Danger Spillway Water
Subject to Sudden Rise

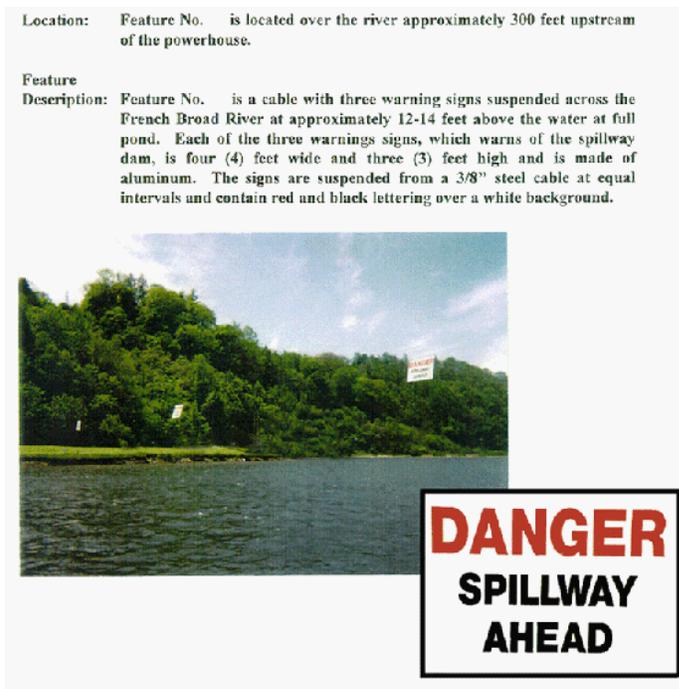
Good use of trigger word, identification of hazard, and explanation of dangerous conditions.

Text is fine for initial layout, but final sign should have proportional borders.
